Research Report 1524

MANPRINT Evaluation: AN/TRC-170 Digital Troposcatter Radio System

MANPRINT EVALUATION: AN/TRC-170 DIGITAL TROPOSCATTER RADIO SYSTEM

Figure 8. The M-720 mobilizer carrying the S-665 shelter. (The actual configuration of the mobilizer differed slightly from the graphic representation.)

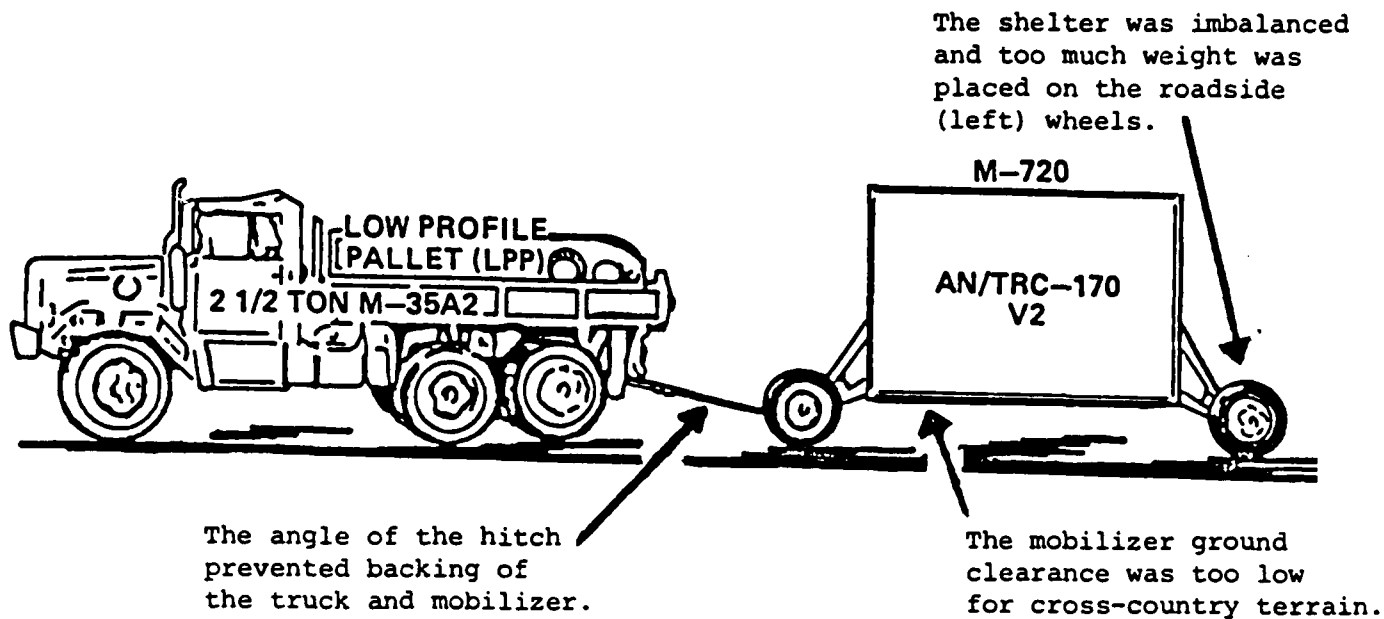
Description of the Problem: Figure 8 shows the M-720 Mobilizer which carries the V2 shelter. The M-720 Mobilizer carrying the V2 electronic and some of the antenna equipment had several limitations on its mobility including:

- a. The loaded mobilizer weighed 8,620 lbs when loaded with tactical cargo. The load was 1,150 lbs over the gross weight of the authorized load of 7,470 lbs. The distribution of the weight was unbalanced when the mobilizer was loaded according to the load plan. The left side wheels carried weights of 2,290 lbs and 2,430 lbs for the front and rear wheels. The loads over the left side wheels were 490 lbs and 630 lbs over the 1,800-lb load limit for each wheel. The right side wheels were weighted below the 1,800-lb. load limit.

- b. The ground clearance of the mobilizer was 12 inches below the center of the trailer. The mobilizer struck terrain during cross-country travel and could not cross rough terrain that could have been crossed by the towing vehicle.

- c. The mobilizer cannot be driven in reverse when towed due to the angle of the trailer tongue when hitched. The trailer tongue was raised approximately 2.5 ft at a 35-deg angle when it was attached to the hitch of the 2.5-ton truck. Backing the mobilizer would result in equipment damage to the hitch or tongue as forces would cause the tongue to fold over.

Potential Solutions: The internal shelter configuration had all the electronic components positioned on the roadside of the mobilizer. Perhaps the electronic components could be repositioned on both sides of the mobilizer in order to balance the load. However, the only way to avoid exceeding the weight capacity of the mobilizer may be to use a larger-capacity mobilizer.

Figure 9. The main power panel in the V3 shelter.

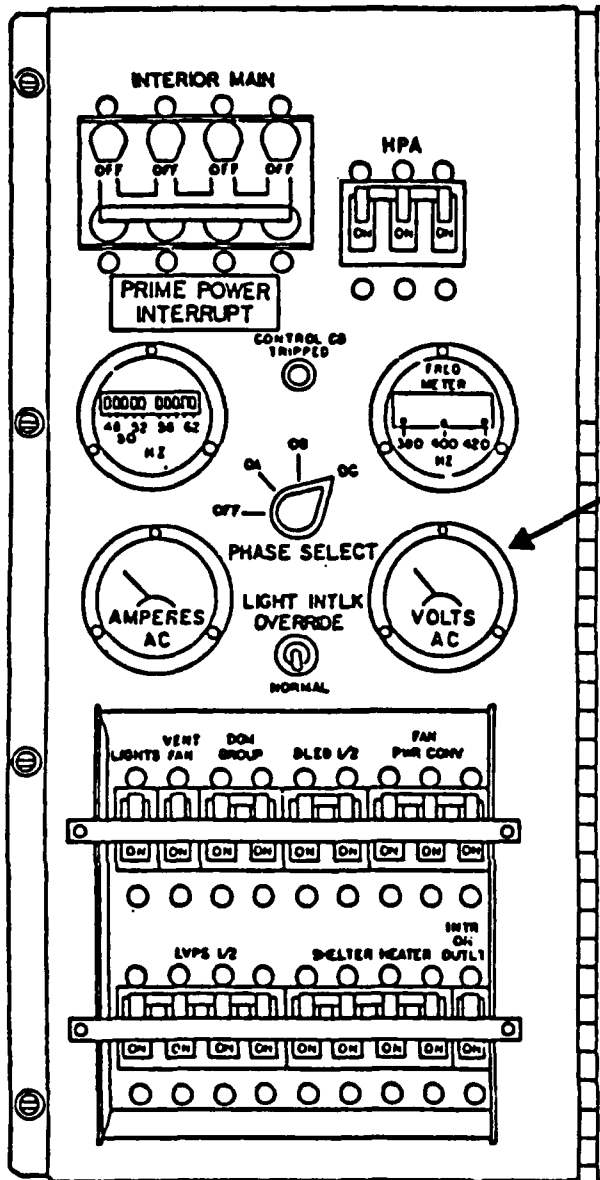
Description of the Problem: There are two 10 kw generators mounted on a single trailer used to support the operation of the V3 system. The generators have two operational problems including:

- a. The generators cannot be switched from one to the other without shutting down the V3 system. The generators need to be switched when fuel is emptied or repairs are required. Once the V3 is shut down, a period of 10 to 15 minutes is required for system warm-up before radio transmissions can be resumed.
- b. Figure 9 shows the V3 main power panel. The generators do not have a built-in capability to adjust for power load variations. When power load variations occur, the operator must see the variation on the power panel voltage meter in the V3 shelter or on the generator and then adjust the generator. Power load variations occur when components in the V3 shelter are turned on or off.

Potential Solutions: Provide the generators with switching capability that provides continuous power without power fluctuations. The generators should be able to automatically adjust for load variations.

Figure 10. The low-profile pallet that was mounted on a 2.5-ton truck and covered for transport.

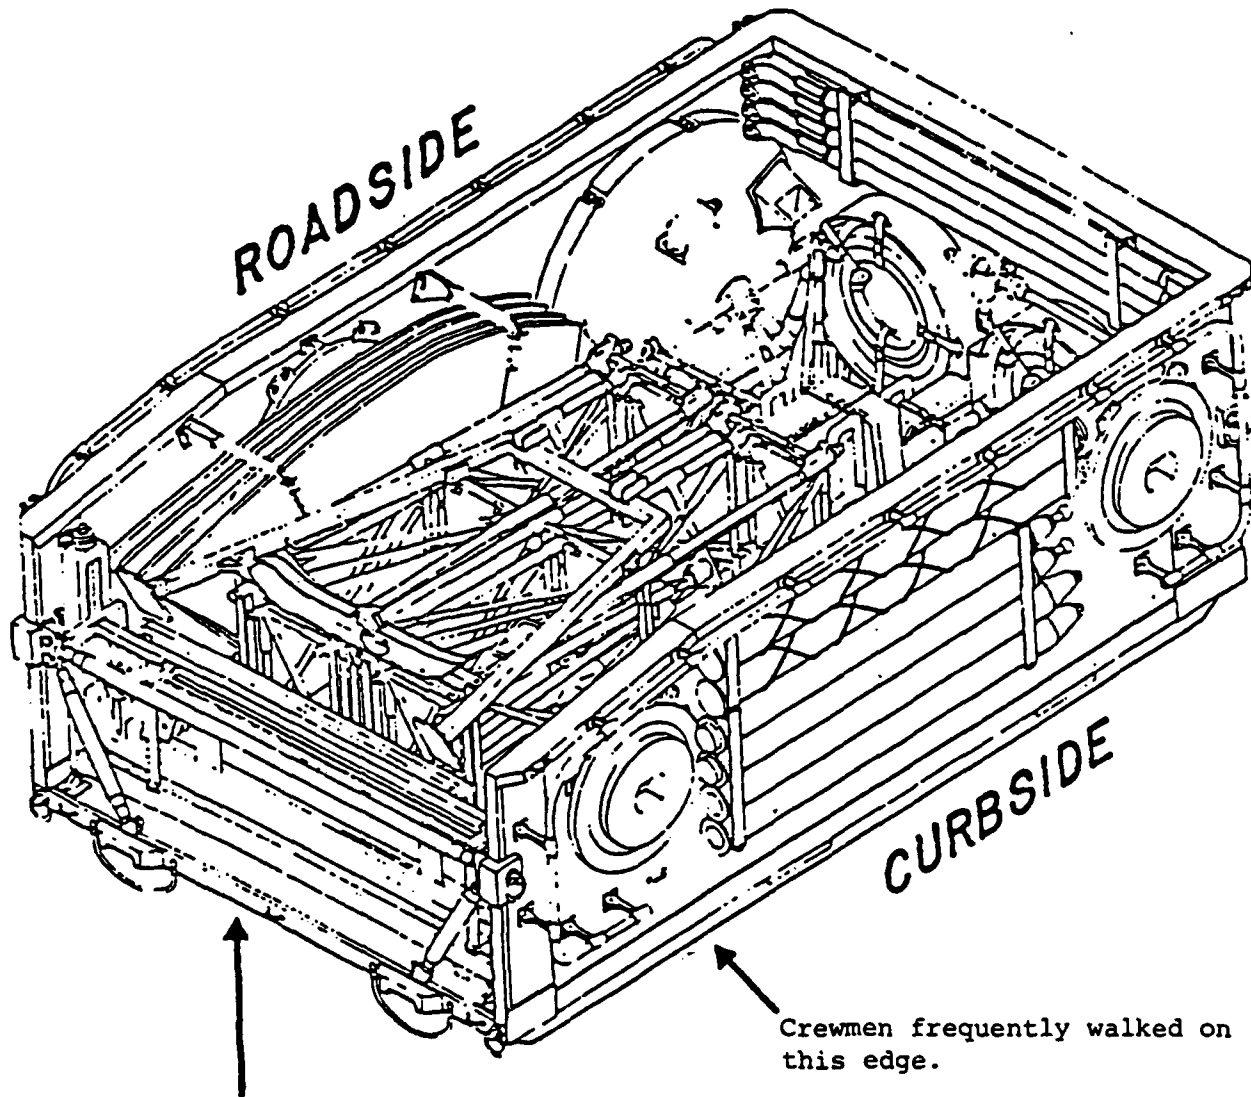
Description of the Problem: Figure 10 shows the low-profile pallet and its contents. The loading and unloading of the low-profile pallet for the V2 system (9.5 ft) antenna is unsafe to perform by three crewmen (AN/TRC-170 V2 crew size). The weights that must be lifted and carried exceed MIL-STD-1472C maximums for three soldiers. The unit (Heavy Tropo Company) does not have other personnel available (TO&E) to support the crews in the field to assist in lifting material. The system can not be set up with a two-man crew making the system un-emplacable if any crew member is injured or otherwise unavailable. The units may set up in isolated locations and other personnel may not be readily available.

Potential Solutions: The crew size could be increased by the addition of a maintainer (29M or 29S) to add to the number of persons available for loading or unloading. The procedures for the truss assembly might be modified to reduce the weight lifted by crewmen when disassembling the truss on the pallet.

Figure 11. The waveguide latches (a) that were difficult to close and the O-ring (b) that fell out.

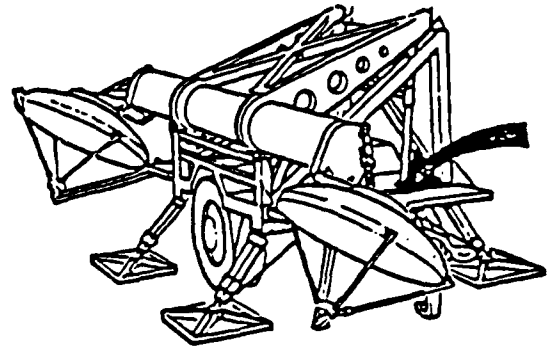
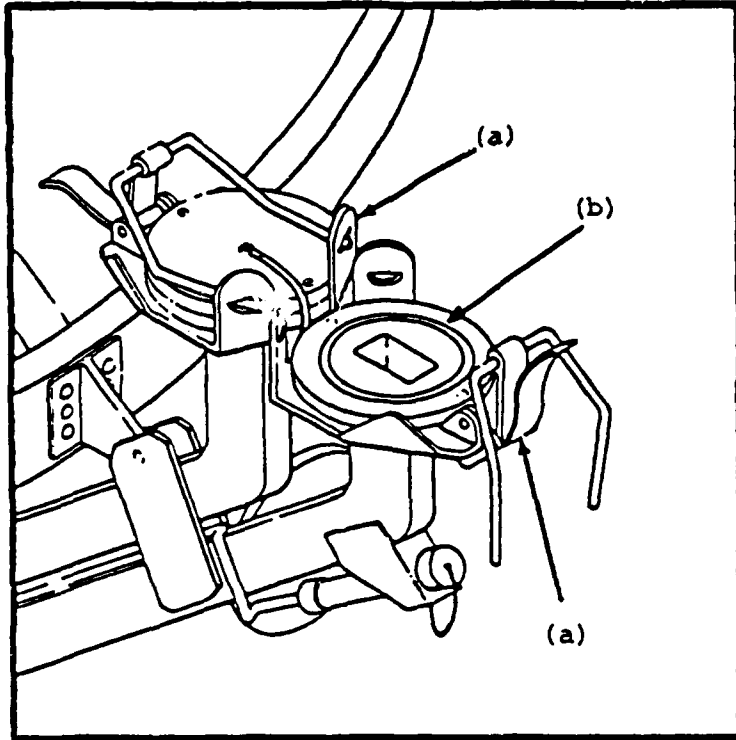
- a. The male plug alignment and signal pins bend, loosen, and fall out.
- b. The male plug O-ring forming the moisture seal falls out making alignment difficult and risking loss of the O-ring. Figure 11 shows the location of the O-ring and latch device.
- c. The latch securing the male plug to the female socket was difficult to manipulate and had to be forcibly closed. The latch could not be closed by crewmen wearing MOPP NBC gloves.
- d. The protective transport containers for the waveguides used on the V2 system were attached to the pallet. The waveguides had to be carried by crewmen from the pallet to the antenna. The exposed waveguides were often stepped on or collided with objects. Figure 12 shows the protective container, while Figure 13 shows the position of the waveguides when laid out on the ground.

Potential Solutions: The waveguides should be durable enough for the field environment in which they will be used. Operator training should address the sources and prevention of waveguide damage, especially if the design of the waveguides remains unchanged. Two soldiers, rather than one, should be used to support the waveguide when attaching or detaching it to the antenna in order to keep it evenly supported.

Figure 14. The lightning protection assembly (LPA) that was erected across the top of the antenna structures.

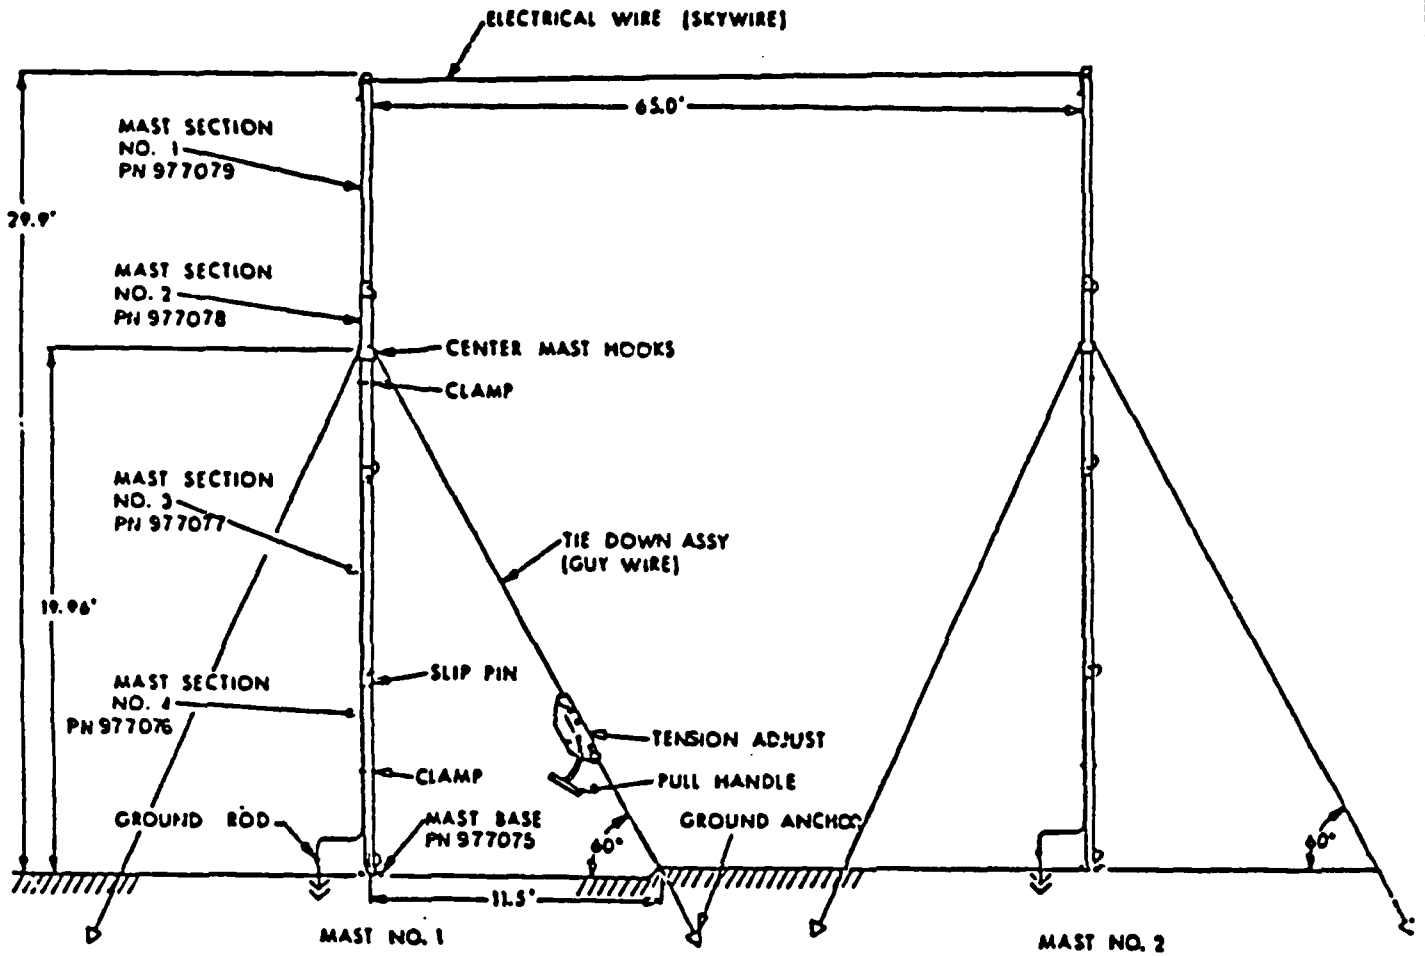
Description of the Problem: Figure 14 shows the LPA configuration that is erected across the top of the antennas. The LPA erection procedures call for four crewmen (crew size is three soldiers). The procedures require one crewman to hold the base plate, one crewman to walk the mast up, and two crewmen to hold the guywires controlling the mast as it rises. The current equipment assembly procedures and the few personnel performing the task may lead to a situation resulting in the collapse of the mast.

Potential Solutions: If the current LPA masts continue to be used, using a hinged base plate would make erection easier and safer, but for safety would require four man crews for erection. Alternately, consideration should be given to use of telescopic antenna mast sections which are already in the supply system. The training program should demonstrate correct erection/dis-assembly procedures to all 26QD6 personnel during specialty training.

Figure 15. A cut-away view of the Pionjar drive motor and of the duckbill anchor.

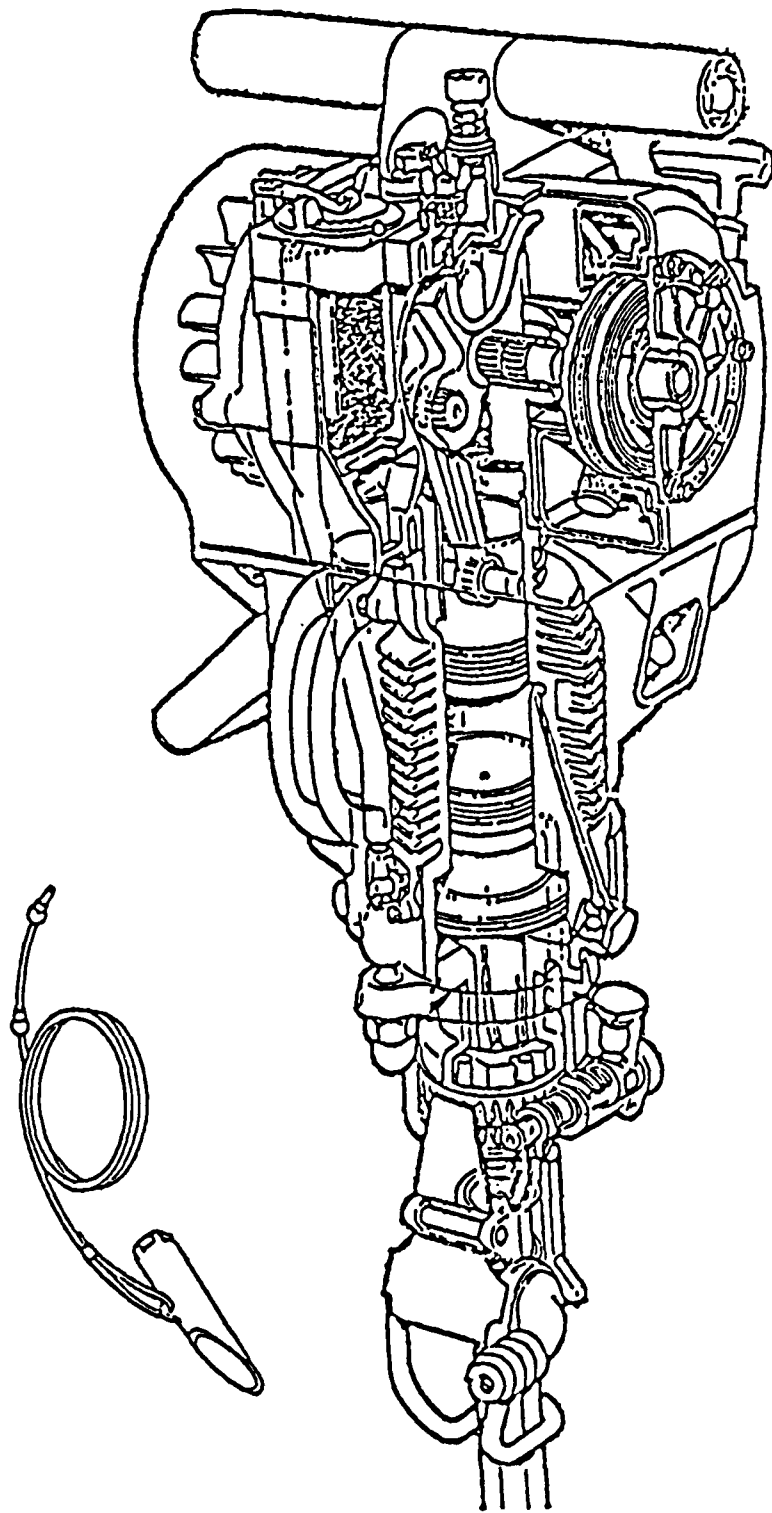
Description of the Problem: Figure 15 shows a cut-away view of the Pionjar drive motor. Problems found on the non-militarized Pionjar included:

Potential Solutions: A separate test of the Pionjar is needed. The device should also be required to meet military packaging and labeling standards. The logistics issue need review.

Figure 16. An example of the type of pin that was difficult to insert and remove.

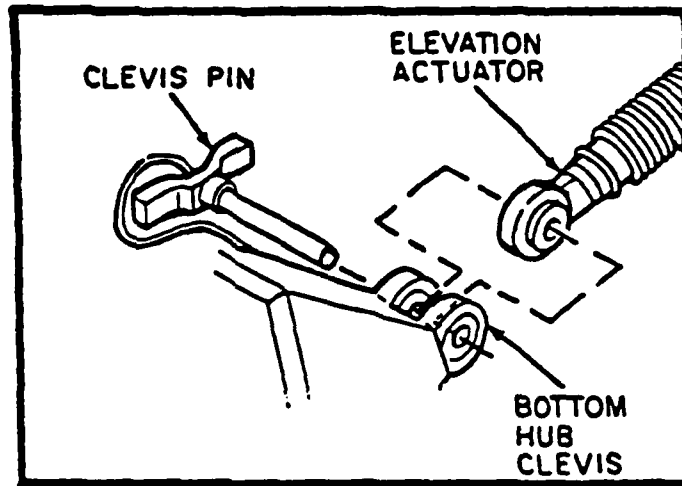
Description of the Problem: Figure 16 shows the type of clevis pins used to secure and assemble equipment. The clevis attachment pins used on the AN/TRC-170 antennas are difficult to handle. The pins are used to hold the antennas together and to secure antenna parts to the low-profile pallet. The pins fit tightly and are difficult to install and remove. The pins have been damaged by attempts to install or remove them using improper tools such as hammers, rocks, and other objects.

Potential Solutions: The pins should be treated with an approved lubricant to control corrosion and facilitate insertion. The holes receiving the pins should be flanged to help insertion/removal. Crewmen suggested that a rubber mallet be issued and used to insert or remove pins.

Figure 17. The 9.5-ft antenna (a), rear truss clamp (b), and bearing ball (c).

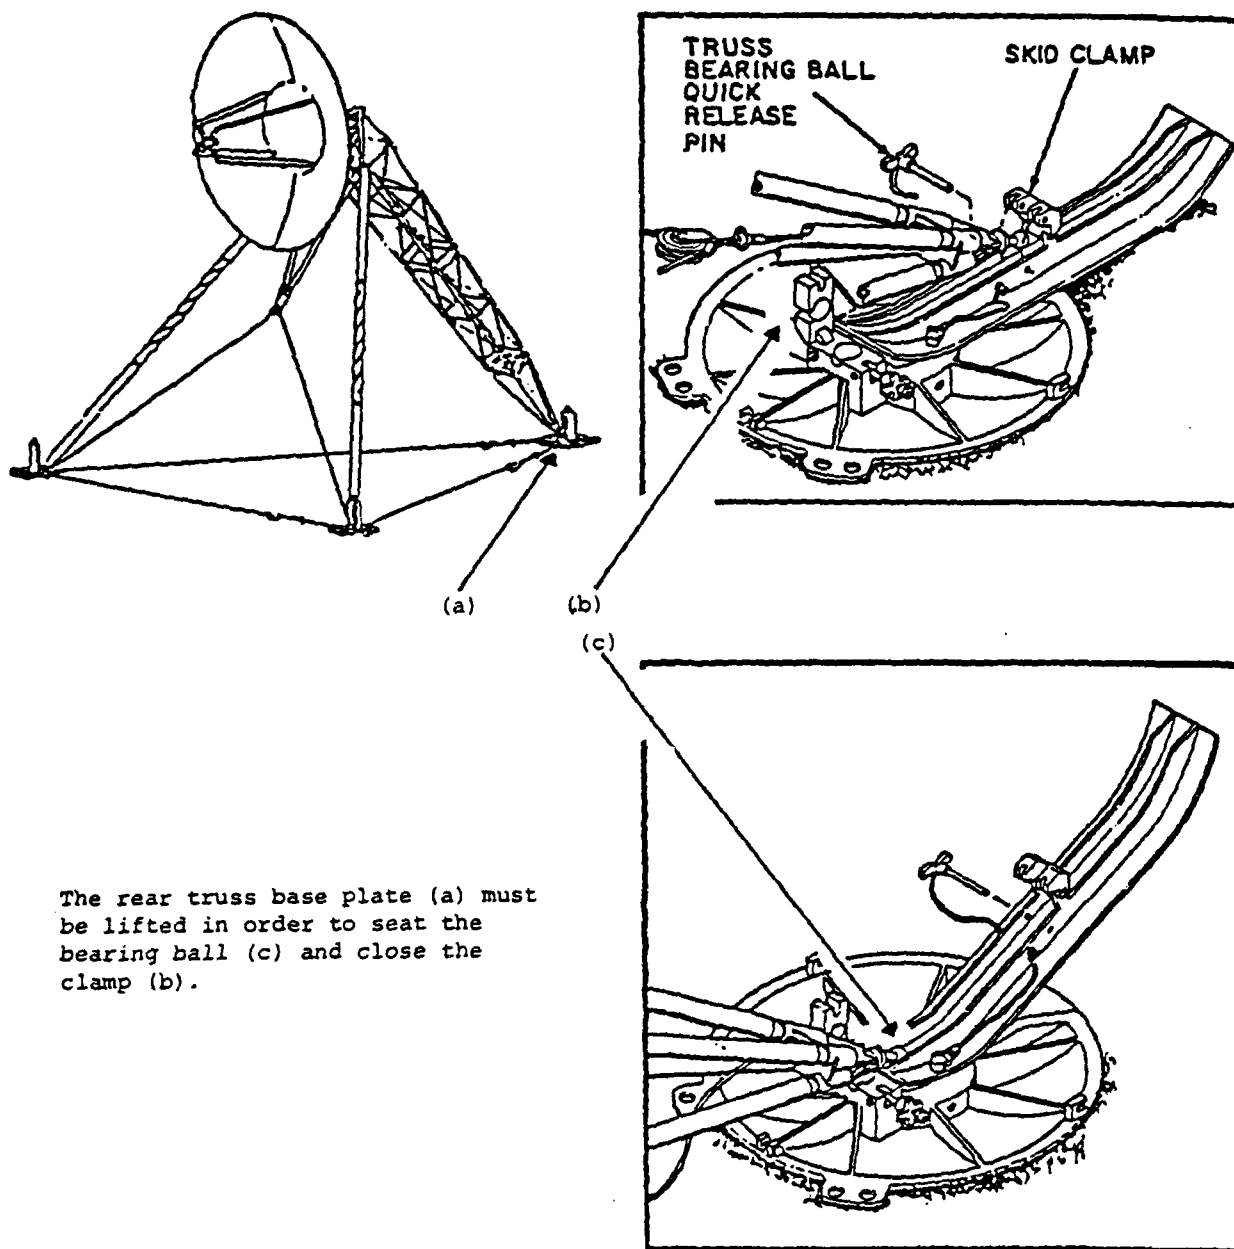
Description of the Problem: Figure 17 shows the rear truss clamp and bearing ball configuration. The rear truss clamp which locks down the bearing ball on the end of the truss assembly binds. The clamp cannot be closed without lifting the loaded base plate, a job that is heavy and dangerous. The problem occurs when the antenna is set to the 15-ft height versus the 10-ft height.

Potential Solutions: The rear clamp assembly needs to be modified. The new antennas in production should be modified prior to fielding.
